2 SITE CHARACTERISTICS

2.5 Geology, Seismology, and Geotechnical Engineering

PSEG Site early site permit (ESP) application, Section 2.5, "Geology, Seismology, and Geotechnical Information," of the Site Safety Analysis Report (SSAR), Revision 3, contains information on geologic, seismic, and geotechnical characteristics of the proposed ESP Site. The applicant (PSEG) followed guidance in Regulatory Guide (RG) 1.208, "A Performance Based Approach to Define Site-Specific Earthquake Ground Motion," to define the following four zones around the site and conducted investigations in those zones that became progressively more detailed passing from site region to site location:

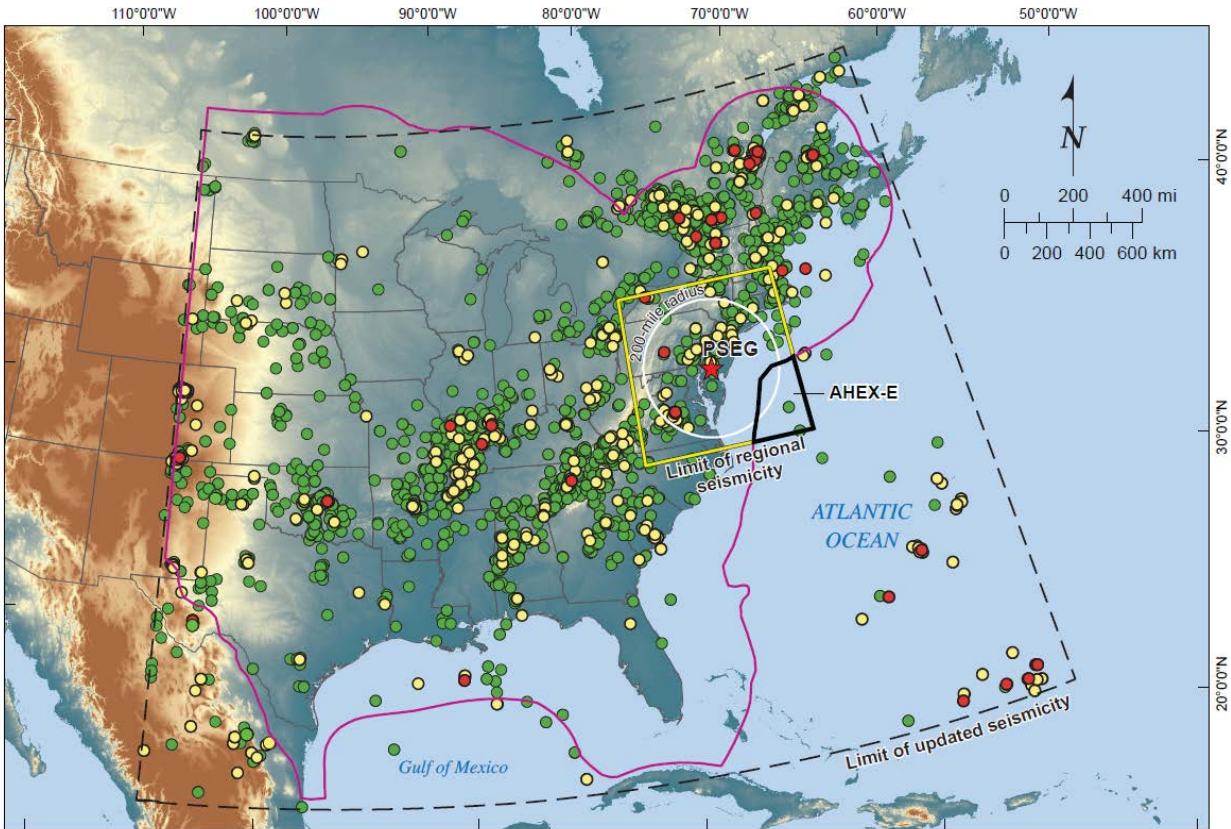
The input model for the PSEG PSHA study is primarily the NUREG-2115 seismic source model. Since the NUREG-2115 model does not cover the PSEG Site region fully (a radius of 320 km (200 mi)), the applicant developed a small regional seismic source to be added onto the NUREG-2115 model to cover the site area fully. The applicant named this new source 'Atlantic Highly Extended crust (AHEx-E)' and developed earthquake recurrence rates within this source using the same process utilized in the NUREG-2115 model. The applicant's AHEx-E source is shown as the black polygon in Figure 2.5.2-1 of this report.

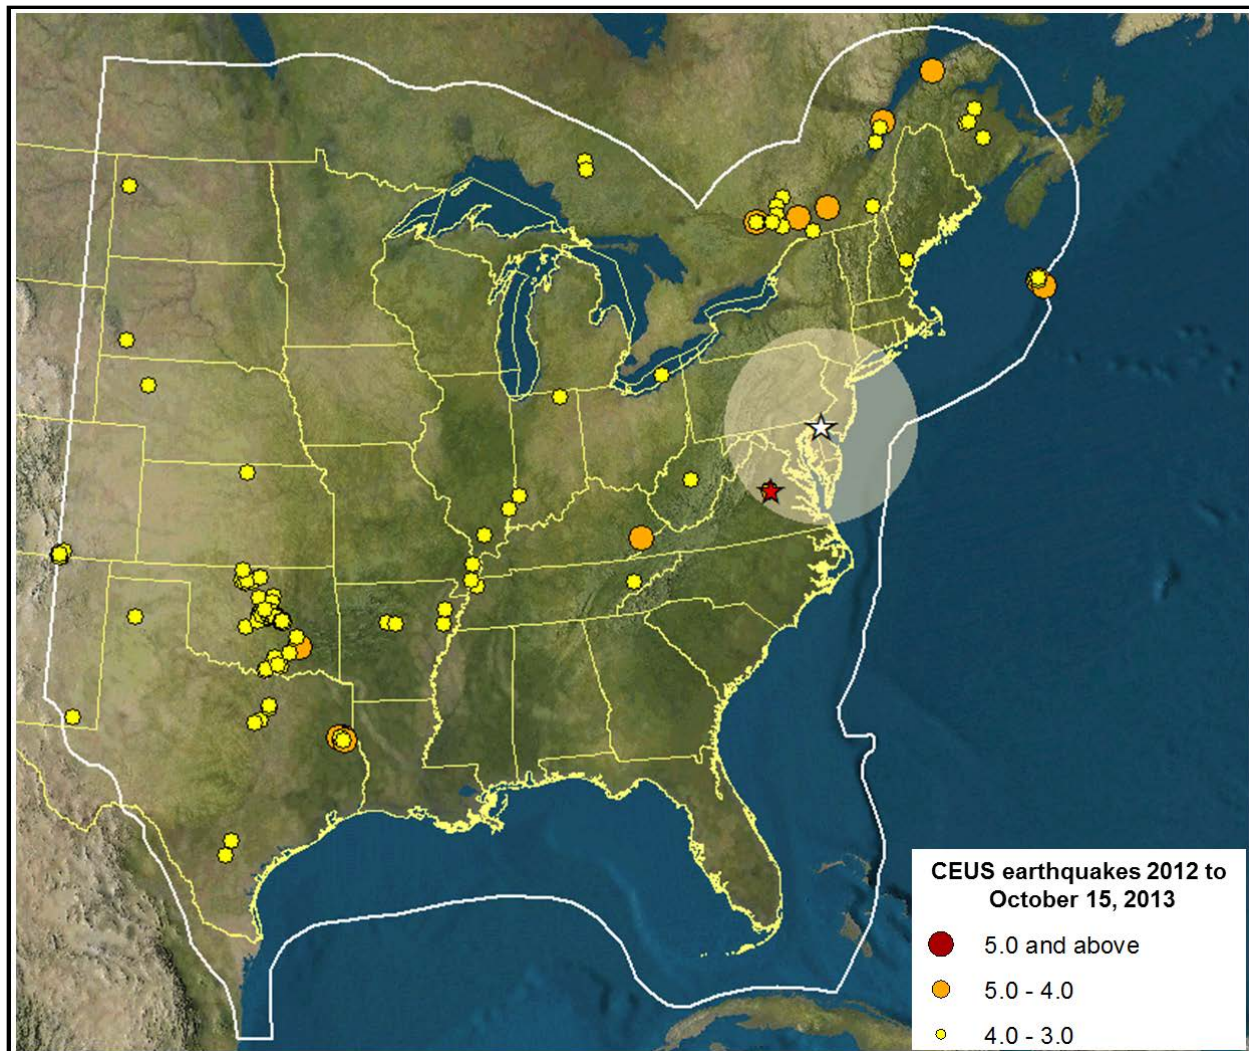
However, due to the large magnitude of the **M5.8** Mineral, VA earthquake, the staff inquired further and issued to the applicant two RAIs regarding the impact of the 2011, Mineral, VA earthquake on the PSEG Site seismic hazard analysis. Specifically, in RAI 71, Question 02.05.02-11, the staff requested that the applicant assess the impact of the 2011, Mineral, VA earthquake on the PSEG Site seismic hazard analysis regarding potential changes in earthquake recurrence rates in the vicinity of the earthquake's hypocenter, and their potential impacts on the site's calculated hazard. In an August 29, 2013, response to RAI 71, Question 2.5.2-11, the applicant performed sensitivity calculations to demonstrate that using updated earthquake recurrence rate parameters, to include the **M5.8** Mineral, VA earthquake, had no significant effect on the seismic hazard at the PSEG Site. The applicant performed the sensitivity calculations using the four NUREG-2115 seismic source zones (ECC-AM, MESE-N, MESE-W and STUDY-R) that host the **M5.8** Mineral, VA earthquake. The applicant compared calculations of the mean annual earthquake recurrence rate per degrees squared (for magnitudes greater than 5) and the b-values for the three NUREG-2115 magnitude weighting cases for the four source zones. The applicant concluded that trends in b-values and recurrence rates in the comparisons showed little difference around the **M5.8** Mineral, VA earthquake. Additionally, the applicant compared its original calculations of mean background hazard and mean total hazard at the PSEG Site for 1, 10, and 100 Hz (PGA) with those calculations including the **M5.8** Mineral, VA earthquake. In the August 29, 2013, response to RAI 71, Question 02.05.02-11, the applicant stated:

Based on the staff's review of the applicant's assessment of the **M5.8** Mineral, VA earthquake in the SSAR and in its August 29, 2013, response to RAI 71, Question 02.05.02-11, the staff concludes that the effect of the **M5.8** Mineral, VA earthquake on the mean background hazard and the total mean site hazard at the PSEG Site is negligible and that the applicant's use of the original CEUS-SSC model earthquake recurrence parameters is acceptable. Accordingly, the staff considers RAI 71, Question 02.05.02-11 resolved.

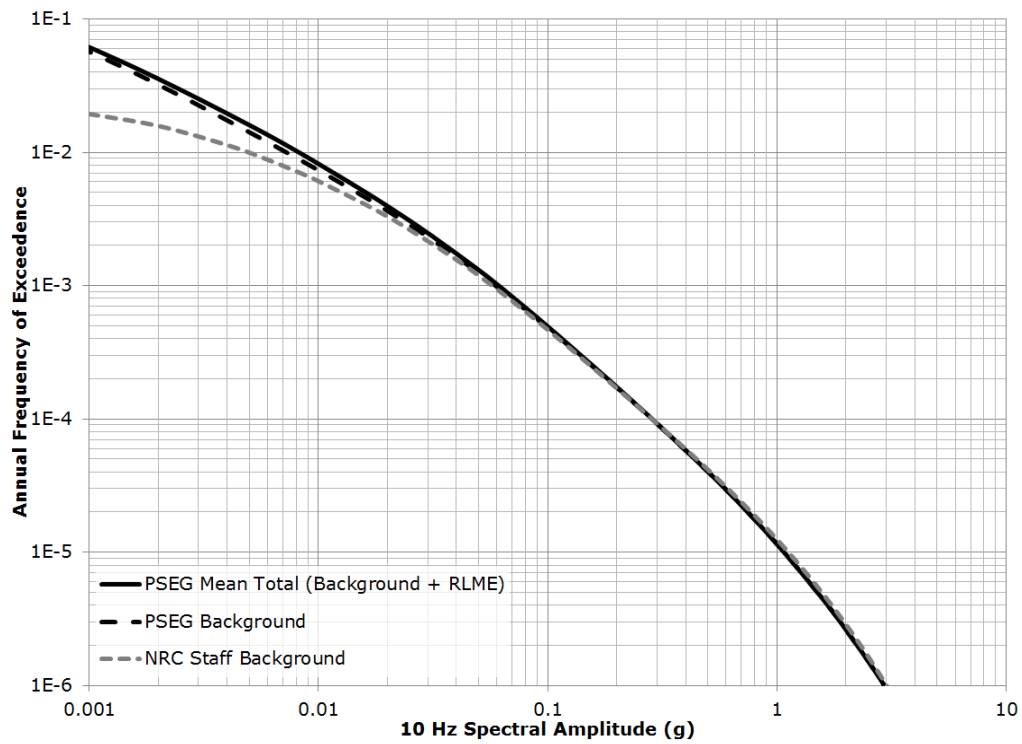
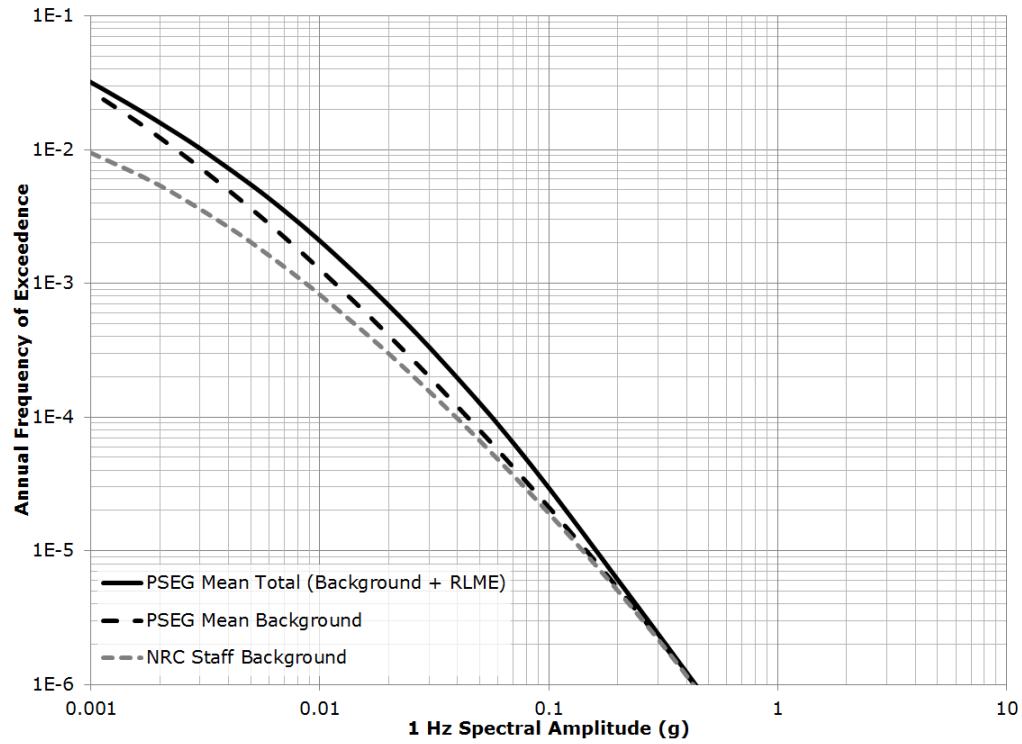
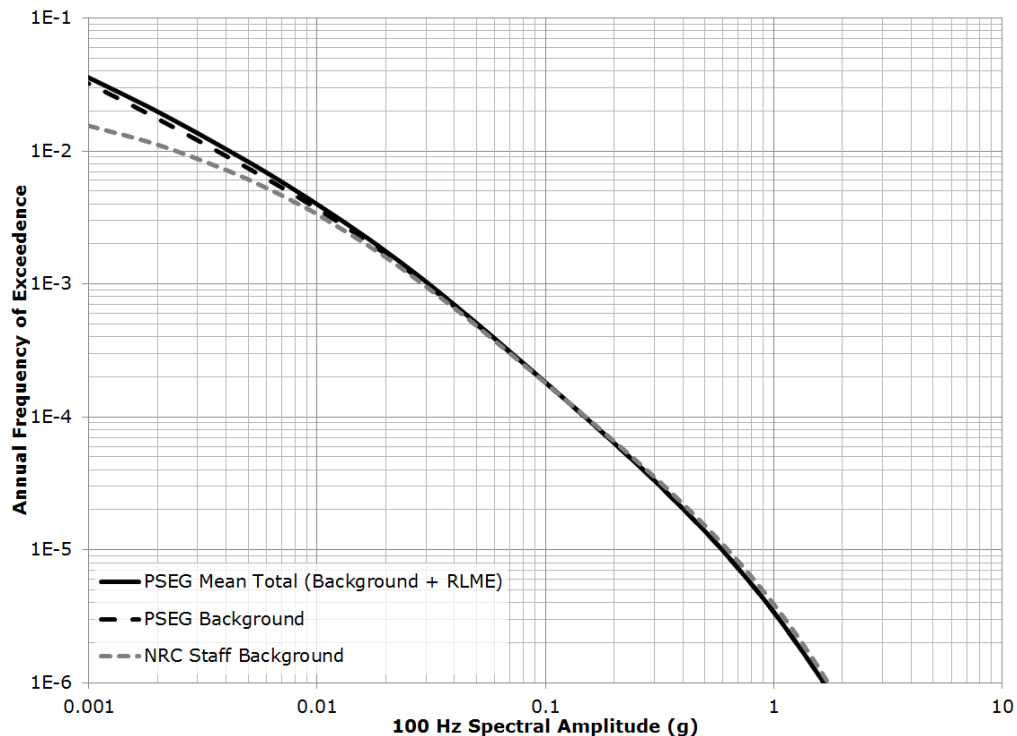
As part of its confirmatory analysis, the staff used the NUREG-2115 CEUS-SSC model background (distributed seismicity) sources and independently calculated the seismic hazard curves at the PSEG Site for all seven ground motion frequencies defined in the EPRI (2004, 2006) ground motion prediction models. The staff's confirmatory calculations did not include the RLME sources. These sources exist at distances beyond 800 km (500 mi) from the PSEG Site and are expected to contribute only at low frequencies such as 0.5 and 1 Hz. From the NUREG-2115 seismic source model, the staff first selected all background seismic sources that are within the 320 km (200 mi) site region. For those seismic sources which are partly within the 320 km (200 mi) site region, but with boundaries extending beyond the site region, the staff used a distance cut off of 500 km (312 mi). Beyond that distance, their hazard contributions will be negligible. Figure 2.5.2-7 of this report shows the staff's results as compared to the applicant's for PGA and ground motion frequencies of 10 and 1 Hz. The staff's confirmatory calculations show that for the annual frequency of exceedances of 10^{-4} , 10^{-5} , and 10^{-6} , the staff's seismic hazard curves are in good agreement with the applicant's background seismic hazard curves. The difference observed between the background seismic source hazard curves and the total seismic hazard curve at 1 Hz shown in Figure 2.5.2-7 of this report is attributed to the contribution of the RLME seismic sources at large distances. As shown in SSAR Figures 2.5.2-25 through 2.5.2-30, at low frequencies, such as 2.5, 1, and 0.5 Hz, distant RLME sources contribute to the hazard at the site. In contrast, at high frequencies only local sources contribute to the hazard. Based on this analysis, the staff concludes the applicant adequately characterized the mean seismic hazard at the PSEG Site.

Figure 2.5.2-8 Comparisons of the staff's site response amplification function with the amplification function determined by the PSEG applicant for the 10-5 annual frequency of exceedance

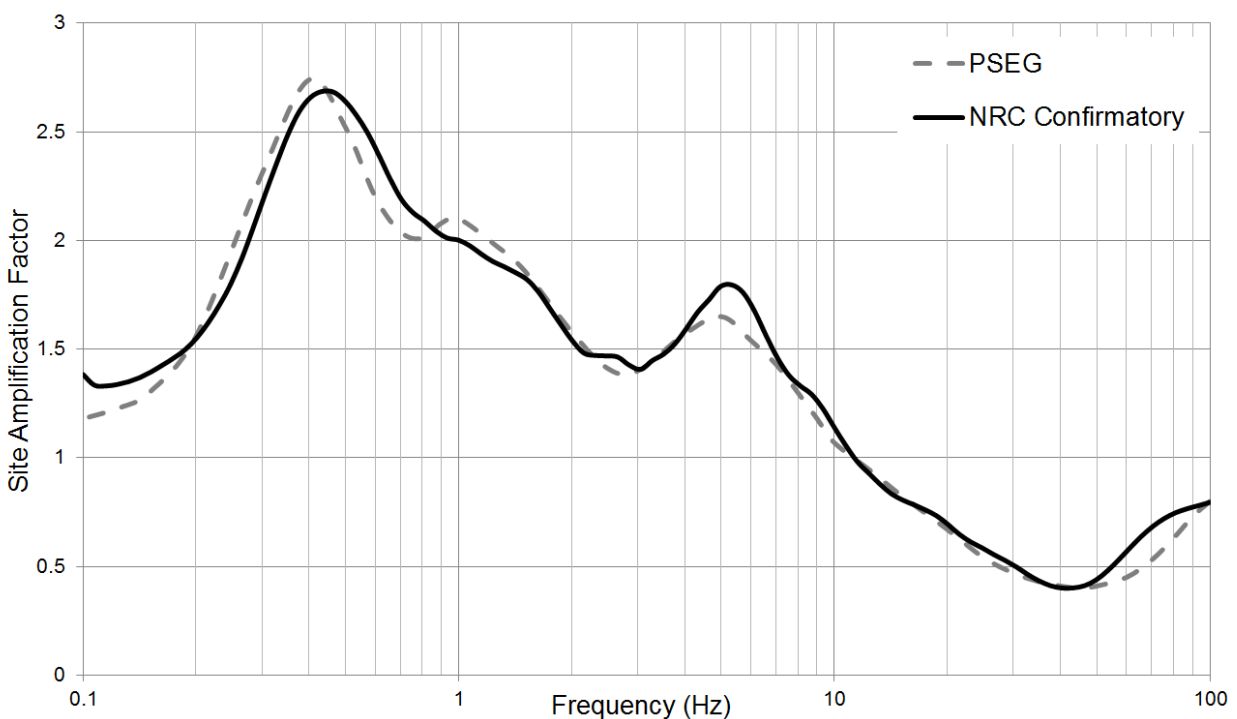
To determine the adequacy of the applicant's site response calculations, the staff performed its own confirmatory site response calculations. As input, the staff used the static and dynamic soil properties provided in SSAR Section 2.5.4. To represent the input rock motions, the staff used the applicant's low- and high-frequency 10^{-5} rock spectra. The staff performed its site response calculations using the Strata software (Kottke and Rathje 2008). The staff's site amplification function results are compared with the applicant's results in Figure 2.5.2-8 of this report, which shows that the staff's calculation is similar to the applicant's site amplification factor across the frequency range typically important for engineering purposes (i.e., 0.5 to 10 Hz) and they are within the limits of uncertainties expected from these calculations. Based on this assessment, the staff concludes that the applicant's site response calculations adequately characterize the site effects at the PSEG Site.

Figure 2.5.3-1 Site vicinity and site area geology and seismicity (Reproduced from SSAR Figure 2.5.3-1)

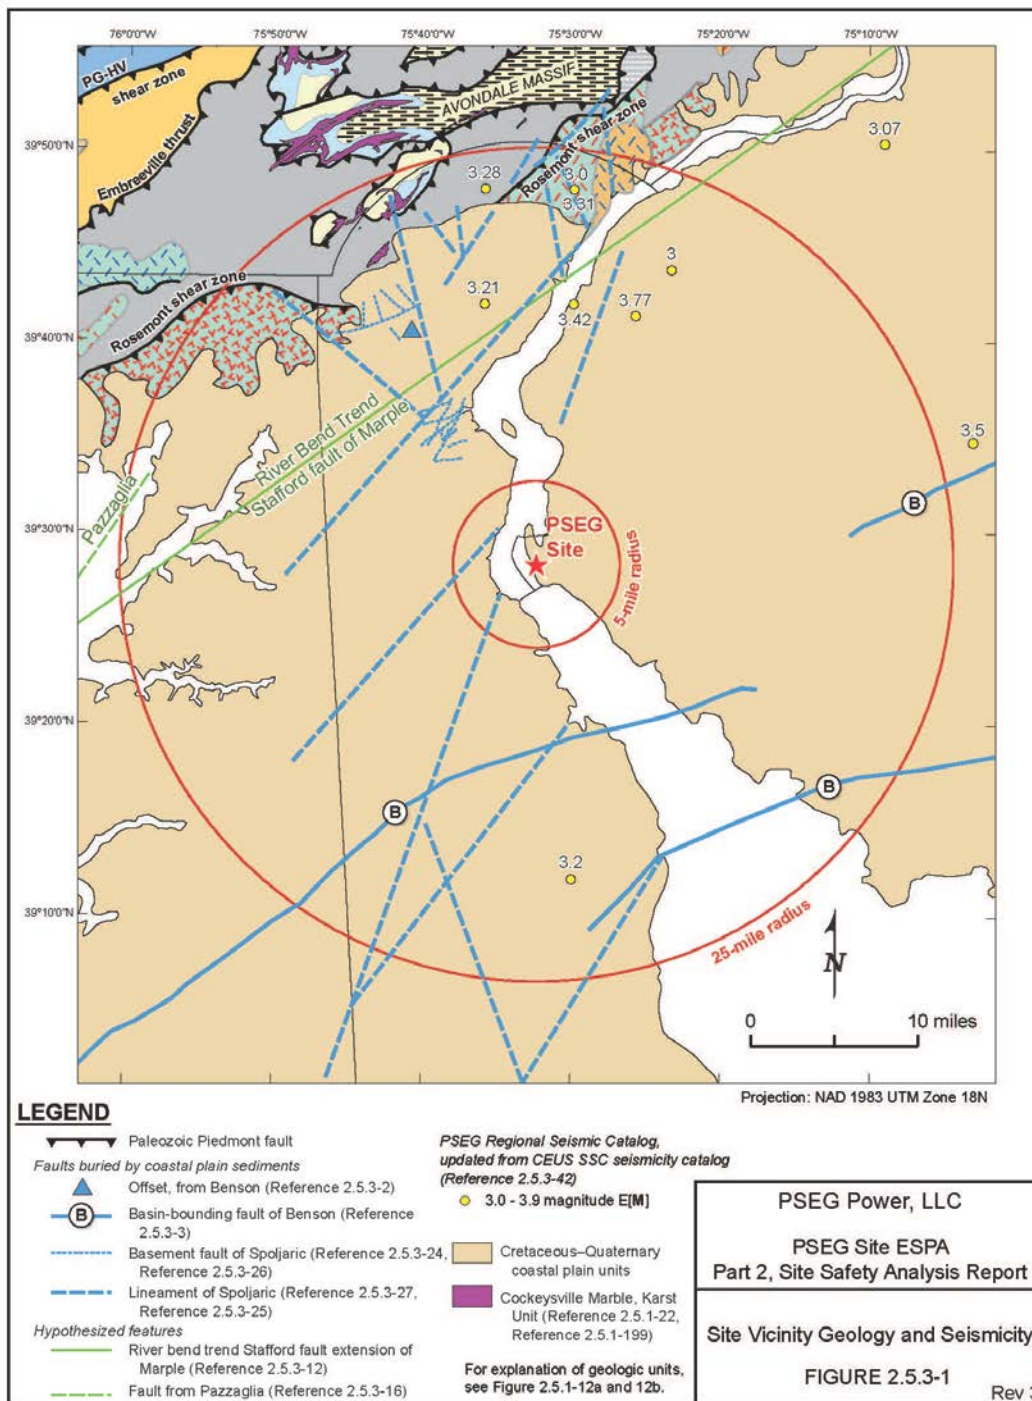
Figures 2.5.3-1 and 2.5.3-2 of this report show the locations of the postulated basement faults and fault-related lineaments, which comprise the New Castle County faults of Spoljaric (1972, 1973, 1974 and 1979). Figure 2.5.3-1 of this report also shows the locations of the buried structures proposed by Benson (1992 and 2006).

The staff focused the review of SSAR Section 2.5.3.2.2 on the applicant’s discussion of the subsurface investigative methods used by Benson (1992 and 2006) to determine that the buried faults he described are pre-Quaternary in age and that locations of the faults are accurate. The staff also focused its review on the applicant’s statement that McLaughlin et al. (2002) implemented trenching, borehole, and seismic investigations to assess a lineament identified by Spoljaric (1979) based on satellite imagery for evidence of Quaternary deformation. Figure 2.5.3-2 of this report illustrates the location of the area investigated by McLaughlin et al. (2002) relative to the lineaments identified by Spoljaric (1974 and 1979), which, along with his

Figure 2.5.3-2 New Castle County faults and location of the McLaughlin et al. (2002) study area (Reproduced from SSAR Figure 2.5.1-19)

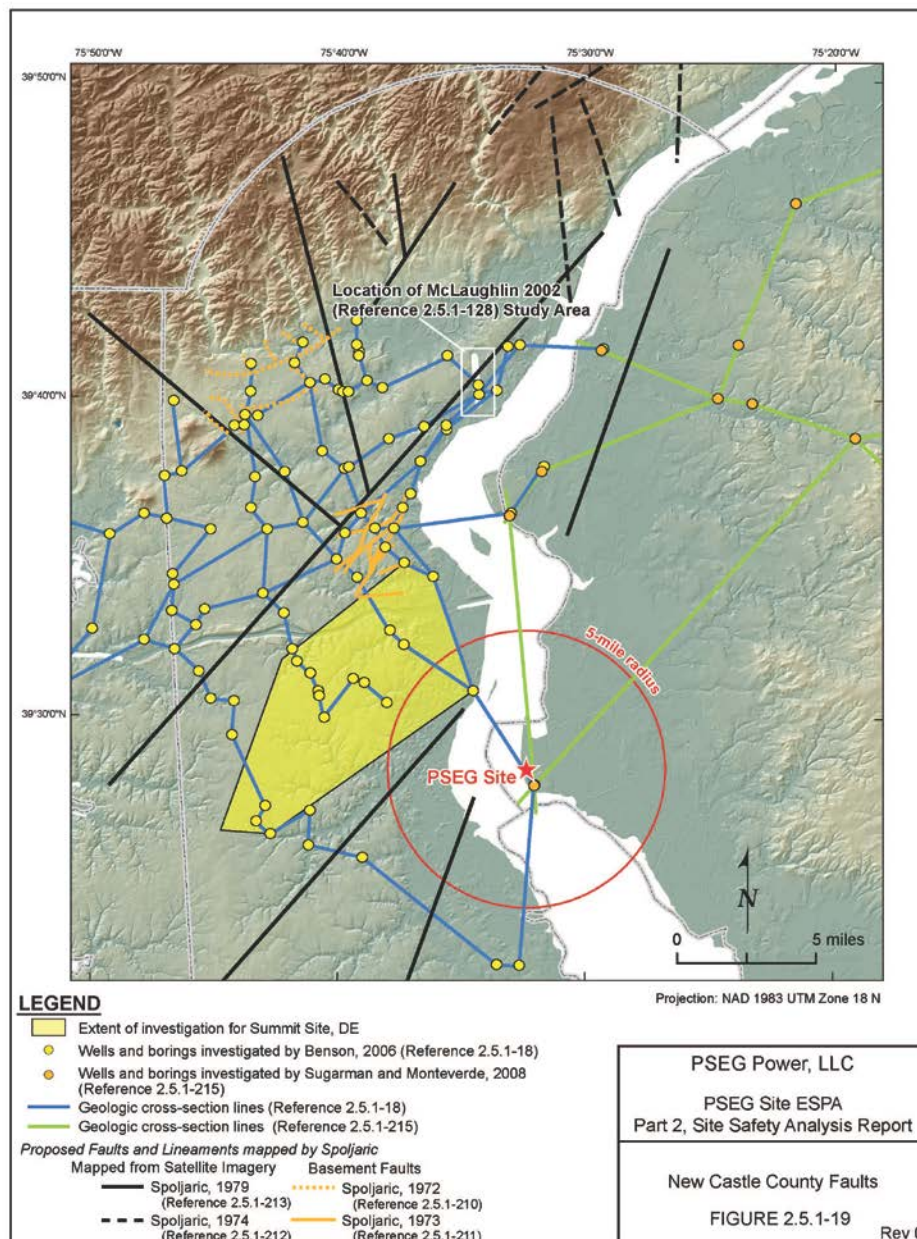
In RAI 44, Question 02.05.03-10, the staff requested that the applicant specify the locations of the seismic reflection line, trenches, and boreholes placed by McLaughlin et al. (2002) to investigate surficial conditions across one of the northeast-trending lineaments defined by Spoljaric (1979) and used to support the conclusion that the lineaments do not represent Quaternary faults. The staff also requested that the applicant provide details about the information derived from the trenches, borehole logs, and seismic line. Figure 2.5.3-2 of this report shows the location of the seismic line relative to the lineaments that comprise the New Castle County faults. In a February 10, 2012, response to RAI 44, Question 02.05.03-10, the applicant stated that the information reported by McLaughlin et al. (2002) included a seismic reflection line designed to image the top 457 m (1500 ft) of subsurface stratigraphy, three borings 107 to 158 m (350 to 550 ft) in depth designed to intersect postulate faults, and five 1.5 to 2.4 m (5 to 8 ft) deep trenches for examining surficial strata. The applicant stated that location of the borings and trenches along the seismic line was within a mile of the northeast-trending lineament, and that the PSEG Site was about 19.3 km (12 mi) south of the study area of McLaughlin et al. (2002) as shown in Figure 2.5.3-2 of this report. The applicant reported that the field investigations conducted by McLaughlin and others (2002) did not reveal any evidence of shallow tectonic deformation due to folding or faulting associated with the lineament along the seismic transect.
